**ADDENDUM NUMBER ONE
TO PLANS AND SPECIFICATIONS
FOR**

Henderson Park Pavilion 804 Old N. Market Street Brenham, Texas

August 13, 2026

A4.2

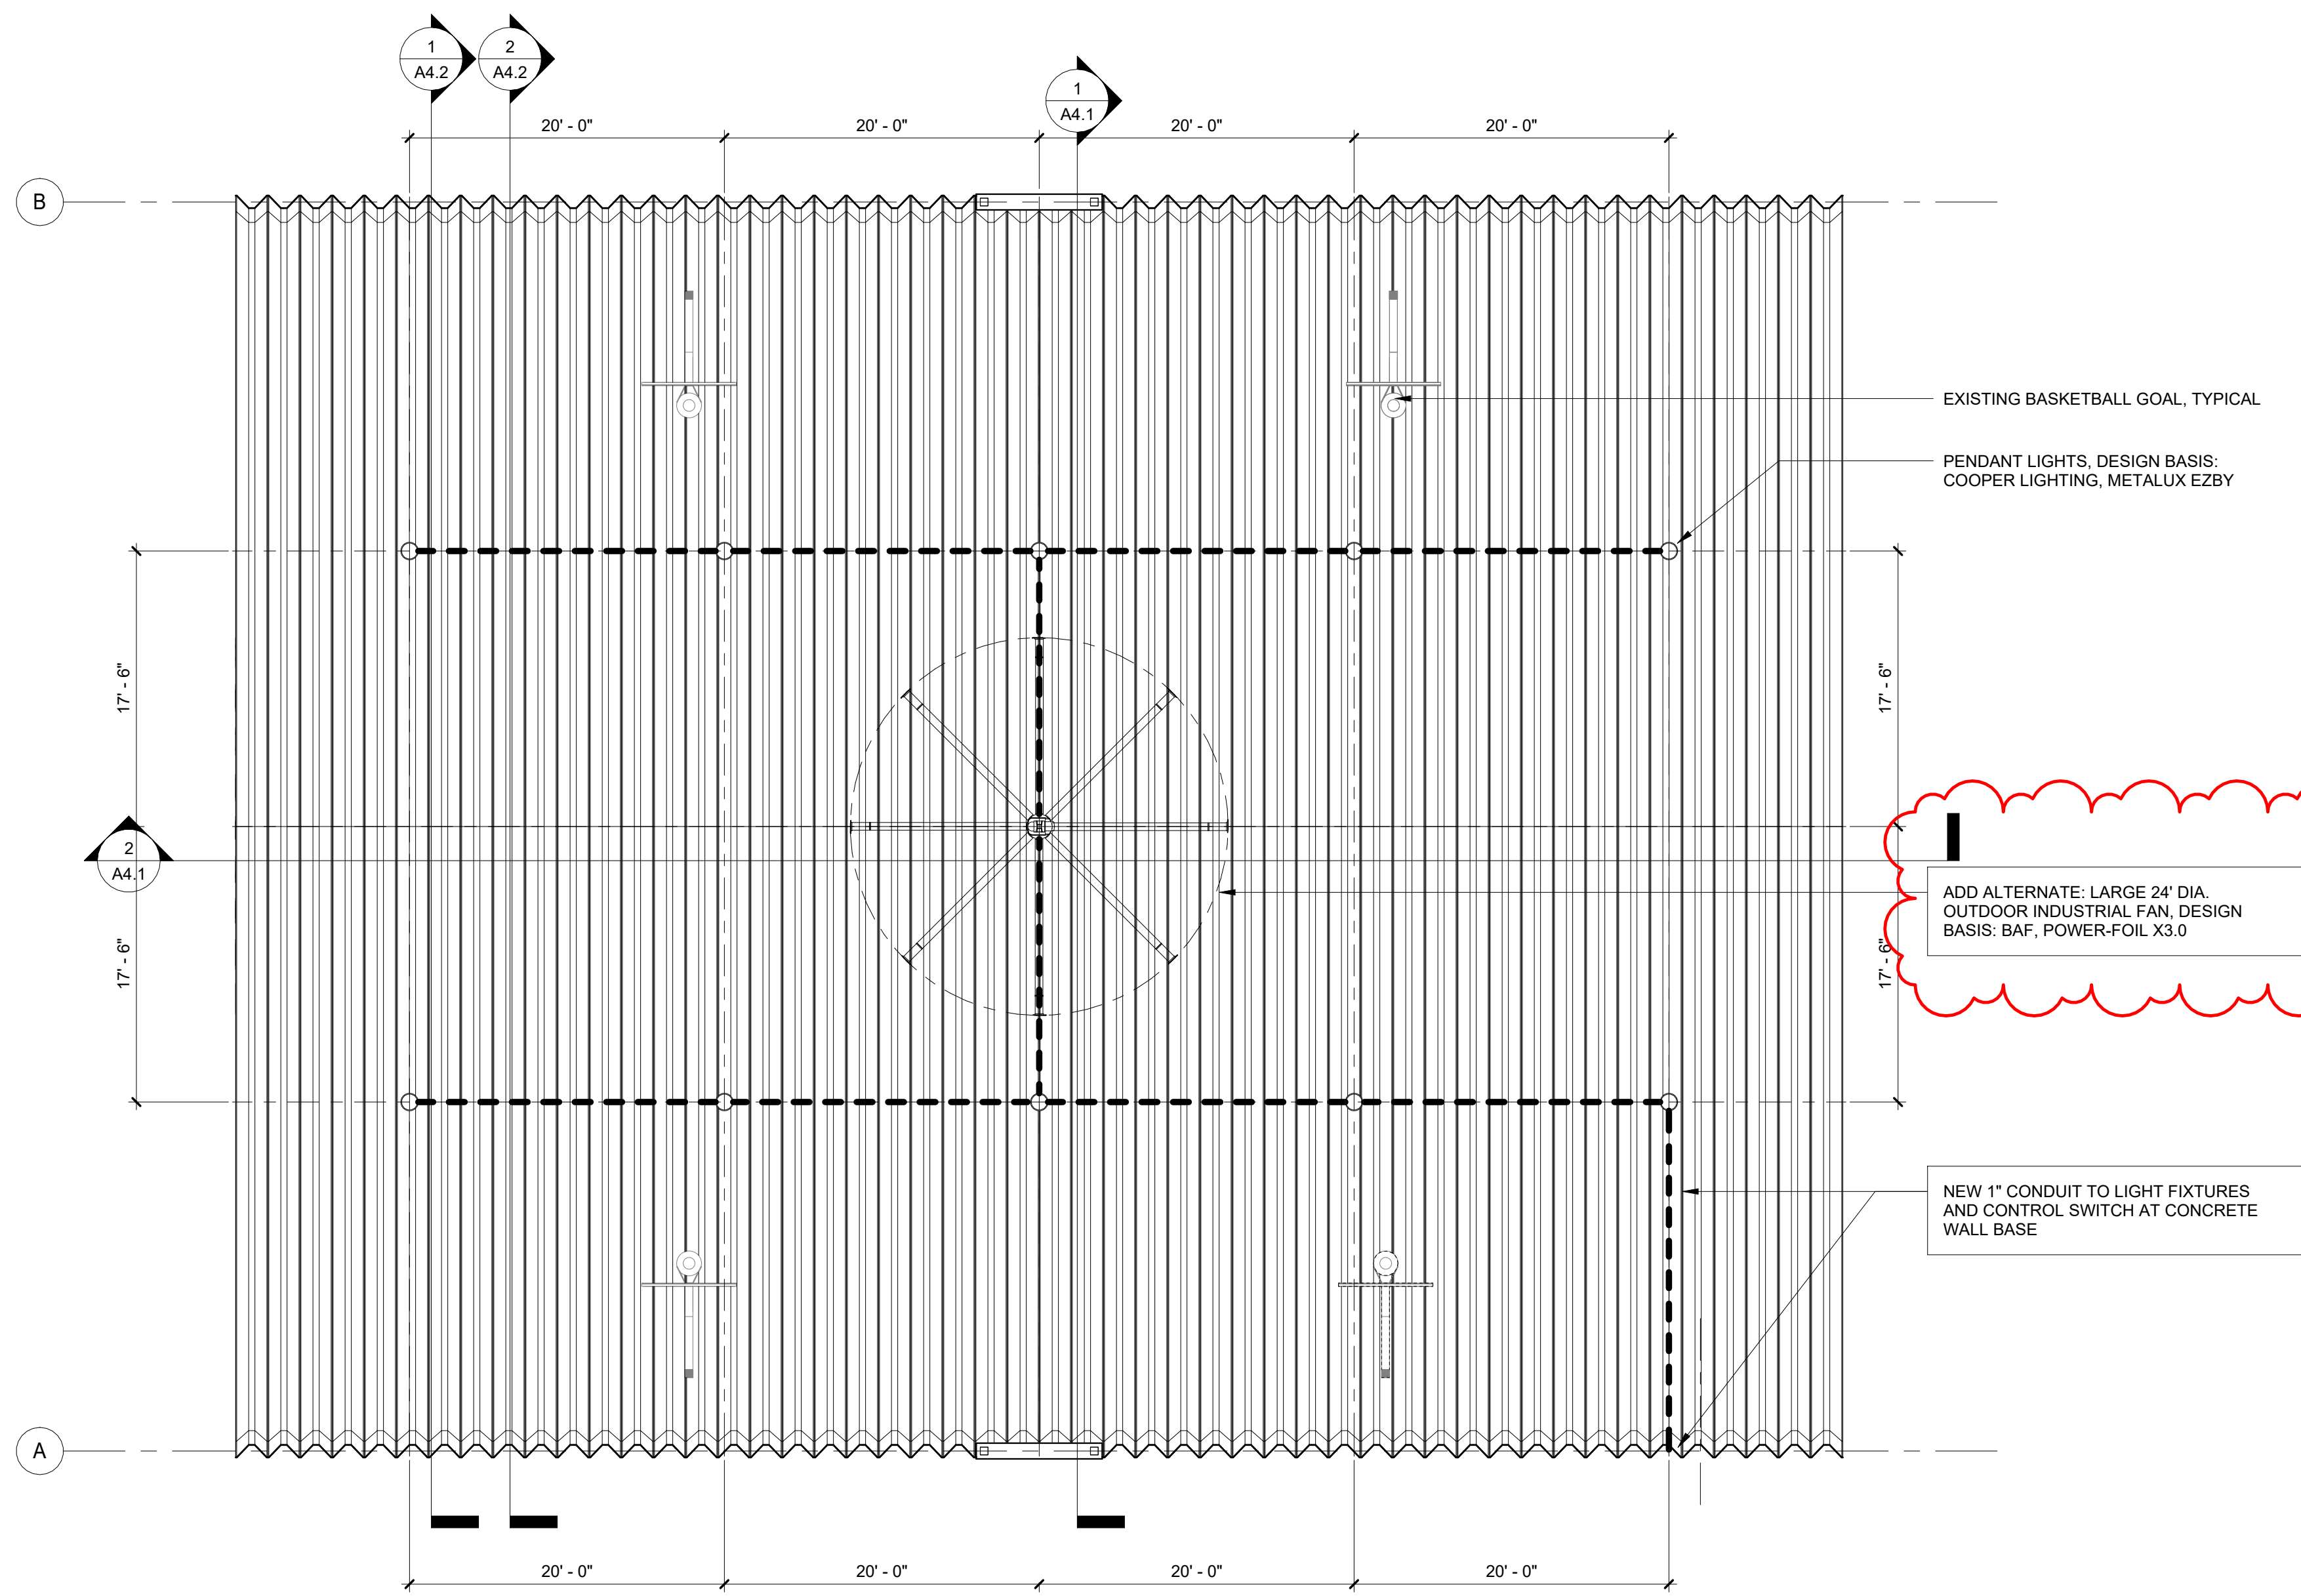
2. **REVISION:** see A8.1 Sheet for Sealed title block.
3. **REVISION:** see drawing sheets A3.1, A4.1, A4.2 and A.8.1 for revised wording for Fan Alternate requirements and revised Architectural specifications (see attached specifications section 012300 revisions) on page 4 of Addendum 01.

Add Alternate Scope: If accepted, furnish and install one (1) large outdoor industrial fan suspended at the interior apex of the arch structure as indicated on Drawing A4.2. Design basis: Big Ass Fans (BAF), Powerfoil X3.0. Include the fan unit, all structural suspension hardware, and all associated electrical work including wiring, conduit, variable-speed drive (if applicable), and connections from the electrical panel. All electrical work shall be performed by a licensed electrical contractor on a design/build basis, shall comply with the current National Electrical Code (NEC) and applicable local codes, and the Contractor shall coordinate available circuits with the Owner and circuit the work accordingly.
